POSITION OF JAPAN ON EMERGENCY STOP SIGNAL

Note: The text reproduced below was prepared by the expert from Japan. It refers to document ECE/TRANS/WP.29/GRRF/2006/2. Its aim is to state Japanese position on how activation and de-activation of the Emergency Stop Signal should be prescribed.

A. PROPOSAL FOR AMENDMENTS TO ECE/TRANS/WP.29/GRRF/2006/2

Figure. Limit values for M1 and N1 vehicles

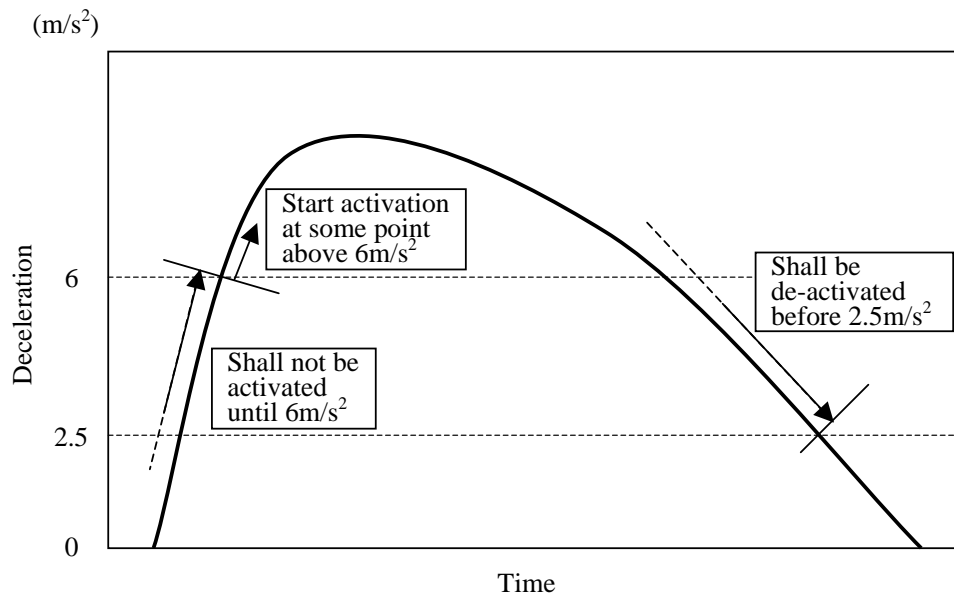
Regarding the limit value, 6 m/s^2 for M1 and N1 is selected considering an informal document distributed at the 51st session of GRE (Informal Document No. 9), which recommends 6 m/s^2 as a lower limit for activation based on study conducted in Japan. The limit value of 5 m/s^2 for other categories is selected considering the current proposal (ECE/TRANS/WP.29/GRRF/2006/2), which proposes lower limit values for categories other than M1 and N1.

Following figure shows the schematic diagram of the limit values for M1 and N1 vehicles.
